Partial Underground Analysis— TRTP Project

Project Segment 8A Corridor

SCE Partial Underground Alternative Analysis

Figure 2.5-3
Conceptual Plan View of a
500-kV GIL Transition Station

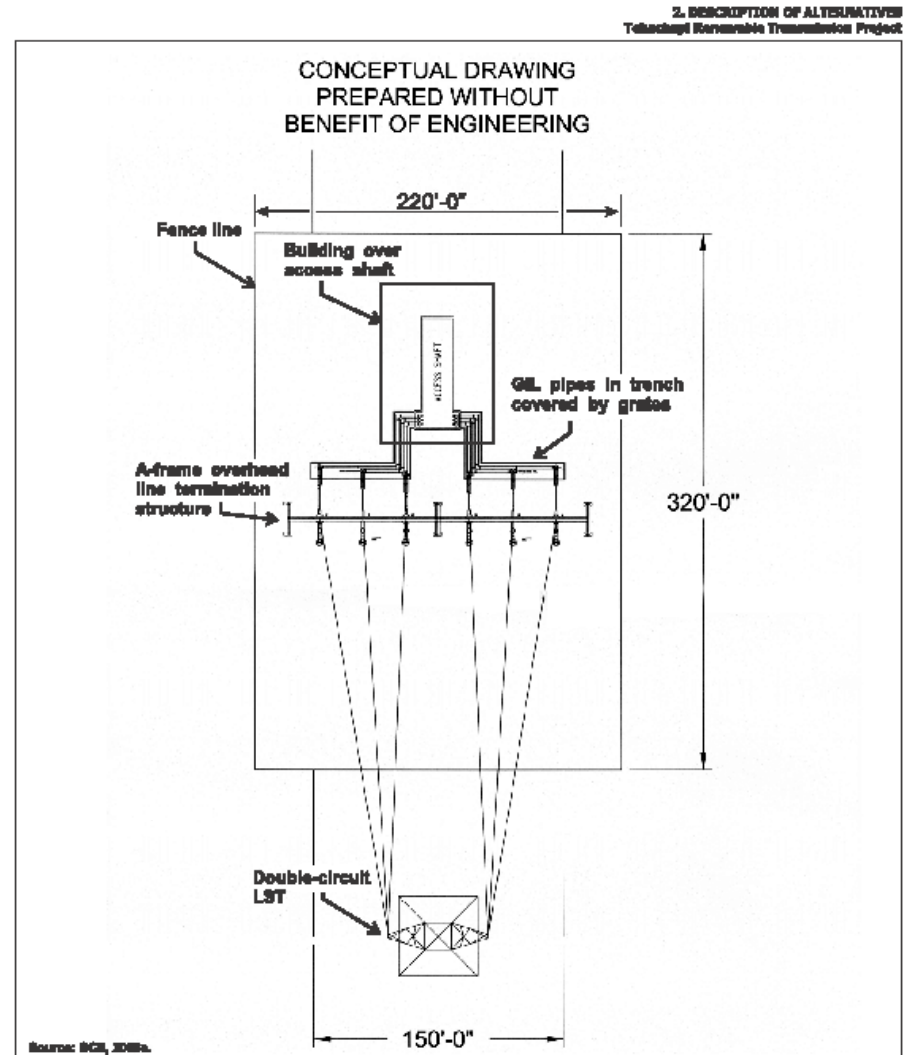
SCE asserts the size of the transition station to be 220 feet wide and 320 feet long, thereby implying these structures would be too big and not fit in the current right of way.

Note: the 220 foot width

- By arranging the transition in vertical configuration as oppose to horizontal configuration the width of the facility can be reduced
- The length of the configuration has less bearing on the footprint due to the fact that the constraint to the project is the 150 width of the right of way
- See attached sketches

Method of Construction

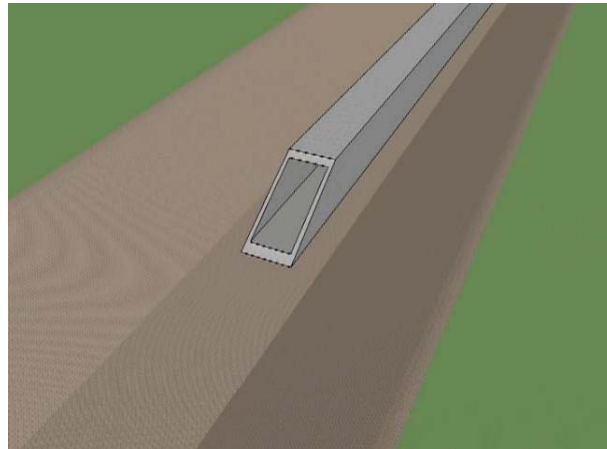
SCE proposes an 18 foot diameter deep tunnel with various systems, including vent systems, SCADA, power source, etc. In addition the tunnel is expected to be 100 foot deep on the eastern side and up to 420 feet deep on the western side. It is this depth in tunneling that is increasing the cost exponentially. SCE is proposing a using a TBM (Tunnel Boring Machine). The type of transmission line identified was gas insulated transmission line (GIL).

An 18 foot diameter tunnel with various systems, including vent systems, SCADA, power source, etc. can still be used but in lieu of a deep tunnel, a shallow tunnel in the 50 to 60 foot depth range can be used. By taking this approach it eliminates the TBM, deep shafts, simplifies the constructions, reduces the cost, and reduces the schedule. The GIL transmission lines also have the added benefits of having the option of direct buried or placed above ground.
